# Draft Document For Discussion Only (9-14-2016)

## Purpose of this Document

This document addresses the remaining FDOT review comments that were included with the 90% foundation design. The remaining review comments were not highlighted by FDOT since the comments were not related to the foundation design.

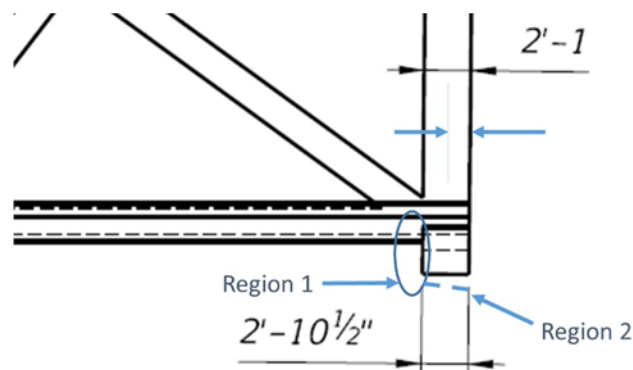
- d. Show duct for the continuity tendon in Section A-A.

**Clarification:** The continuity tendons have been shown in the 90% substructure submittal.

11. Sheet B-16:

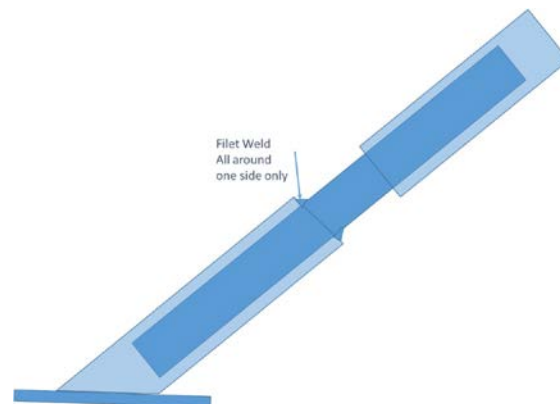
- a. The longest pipe (145'-9") will deflect 2.44 inches under its own dead load. This assumes a standard pipe wall thickness. Even thicker walled 16 inch pipes appear to be unacceptable solutions. Consider a 20 inch or 24 inch O.D. with an X-Heavy wall thickness for the longest pipe and a standard pipe thickness for the rest.

- b. Are the anchor bolts to be embedded in the members? Avoid drill and epoxy options if possible. See suggested detail below in item C to facilitate fit-up.

- c. The pipes will be a maintenance issue long term. Will they be galvanized and then painted. How will inside of pipe be maintained if it is not galvanized? Pipes will attract live loads, thermal loads, and wind loads. See suggested detail (tight fitting inner slide pipe) below to avoid stressing of the pipes. Require pipes to be completely sealed against rain intrusion.

- d. Given the sharply acute angles - How is quality welded insured? Also it is nearly impossible to inspect / perform NDT.

**Clarification:** The final deflection of the pipe is influenced by the contractor's handling procedures. It is bounded by the simple span and fix-fix conditions. The pipes will be chord cambered during welding, with camber values consistent with the contractor's means and methods, in order to have a near straight appearance.

**Clarification:** The anchor bolts are embedded in the members. The steel plates will have slots to accommodate any construction tolerances.

**Clarification:** The pipes are black carbon steel and will be powder coated for long term protection. The connection details have been designed to accommodate all the transient loads. The suggested detail above will not provide the axial stiffness needed to achieve the required natural vertical frequency of the structure.

**Clarification:** FIGG has contacted a specialty welding consultant to develop a welding procedure for the sharply acute angle pipes.
